Report: TAB REPORT
Function: Test, Adjust, & Balance
Date: 06/20/2024

PROJECT
06-17-24 CULVERS - STURTEVANT, WI
(REIMAGE)

Project: 06-17-24 CULVERS - STURTEVANT, WI (REIMAGE)

RTU_2_kitchen_
06/20/2024

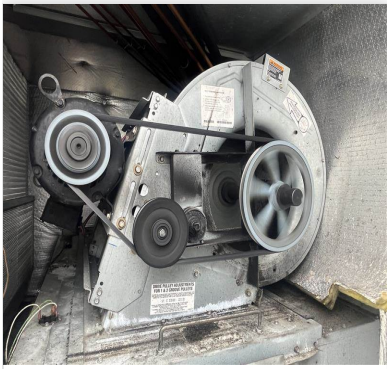
Issue Name : 02. RTU-2 (Kitchen): Low on Supply Airflow
Description : RTU-2 is a 15 ton unit and is supplying 3503 cfm to the kitchen space. For performance and efficiency, blower should operate at around 350 cfm/ton, or 5250 cfm. Per Staff, kitchen is not achieving or maintaining set temp. The RTU is installed with a curb adapter, which may be restricting airflow. Recommend airflow is increased on this unit.

- **06/20/2024 National TAB - Michael McDonnell**
 - The motor sheave is frozen at 1-2 turns open and could not be adjusted to increase the speed of the fan. Recommend sheave is broken free and set to 1 turn open. Regardless, a pulley change will be required to bring the RTU closer to an efficient airflow. The motor is operating at 7.8 amps with an FLA rating of 14.6, so there is room to increase fan speed. Recommend pulley change is performed to increase airflow, consult NTAB.

4_way_diffuser
06/21/2024

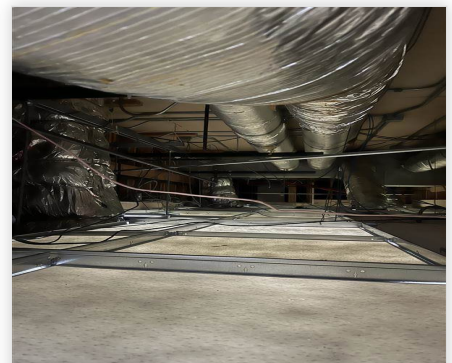
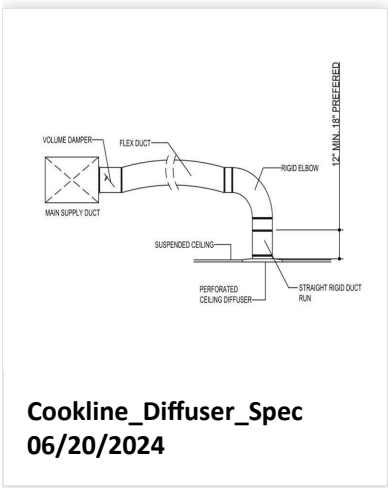
Issue Name : 03. COOKLINE DIFFUSERS
Description : There are three 4-way diffusers installed on the cookline. Recommend these are replaced with perforated diffusers (especially if RTU-1 airflow is increased). Store reports high temps during operation. Recommend 3 additional perforated diffusers are installed on the cookline to increase airflow to cookline, while avoiding hood capture issues.
Created By : National TAB **Assigned To :** National TAB - Brianna Biggs
Status : Open
Priority : High **Asset Tag :**
Originated Date : 06/20/2024 - Michael McDonnell - National TAB

- **06/20/2024 National TAB - Michael McDonnell**
 - Anticipate increasing RTU-2 airflow will cause hood capture issues with 4-ways. Recommend replacing 4-ways with perforated and installing according to Culvers Cookline Diffuser Specification. This entails a rigid elbow and 12-18" of straight rigid duct between the elbow and diffuser. See detail attached.

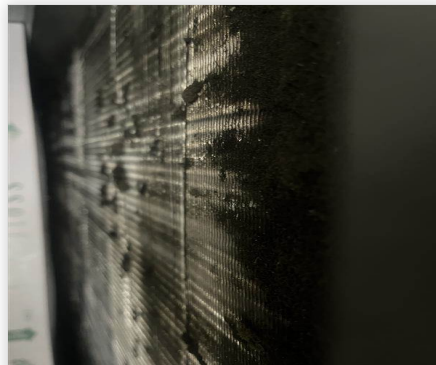
Issue Name : 04. RTUs: In need of Cleaning / Maintenance
Description : Both RTUs are in need of maintenance/cleaning. Evaporator coils, specifically on RTU-1, are in need of cleaning. Additionally, outside air filters need to be cleaned. See other items in need of attention below:
Created By : National TAB **Assigned To :** National TAB - Will Turnbough
Status : Open
Priority : High **Asset Tag :**
Originated Date : 06/20/2024 - Michael McDonnell - National TAB

RTU_2_Condensate
06/20/2024

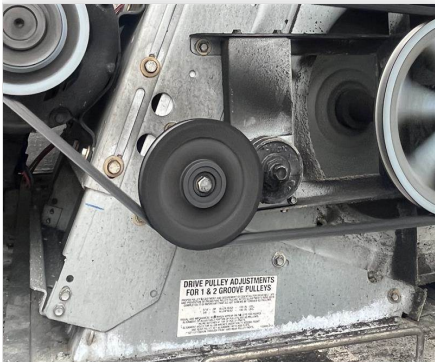
Issue Name : 07. RTU-1: Condensate Drain Routing
Description : Condensate drain on RTU-1 is directed toward roof drain. However, drain is easily clogged and water is pooling on the roof. Recommend drain is routed directly into roof drain as with RTU-2 so water does not pool and potentially leak into store space. See photos below.
